# UNITED STATES PATENT AND TRADEMARK OFFICE

APPLICATION NO.	FILING DATE	FIRST NAMED INVENTOR	ATTORNEY DOCKET NO.	CONFIRMATION NO.
10/027,418	12/19/2001	Himanshu Patel	FXH1011US	2779
9561 7590 06/01/2009 POPOVICH, WILES & O'CONNELL, PA 650 THIRD AVENUE SOUTH SUITE 600 MINNEAPOLIS, MN 55402				
EXAMINER				
ERIZO, DARWIN P				
ART UNIT		PAPER NUMBER		
3773				
MAIL DATE		DELIVERY MODE		
06/01/2009		PAPER

### Office Action Summary

## DETAILED ACTION

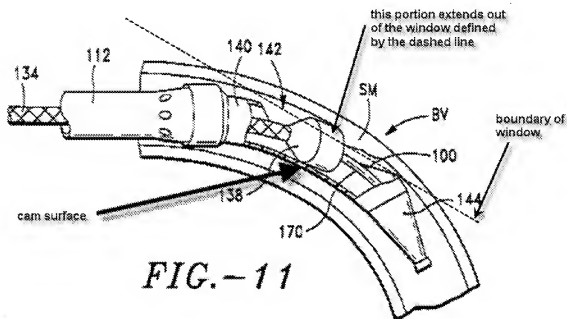
(claim 39) In Fig. 11, Hundertmark discloses a method of removing material (atherectomy) comprising the steps of: delivering a catheter having a tissue debulking device or cutter **138**; deflecting a distal portion of the catheter to a proximal portion of the catheter to expose the cutter, wherein the proximal movement of the catheter through a tortuous blood vessel causes the deflection against an inner cam surface of

the catheter (see attached Fig. 11); and debulking the body lumen by rotating the cutter about an axis to expose the cutter through a cutting window 142.

It is also noted that the inner surface of the catheter adjacent the location of the cutter acts as a cam surface when the distal end of the catheter is deflected, as shown in Fig. 11.

8. With regards to the Hundertmark reference, the applicant argued that Hundertmark fails to teach a cam surface. However, it is noted that the illustrated portion of housing 140 acts as a cam surface once the nose cone 144 has been deflected by the curved passageway of the blood vessel, as seen in Fig. 11. It is also noted that the embodiment shown in Fig. 10-12 is a different embodiment than what is shown in Fig. 1, and that the only disclosed similarities is the use of a hollow shaft circumscribing a guidewire (col. 9, ll. 2-4). Furthermore, the operation of the embodiment shown in Figs. 10-12 do not state that a balloon is used to deflect the cutter (see col. 9, ll. 14-61). Instead, the embodiment relies on the natural bends/curve of the blood vessel to deflect the cutter, as shown in Figs. 11-12.
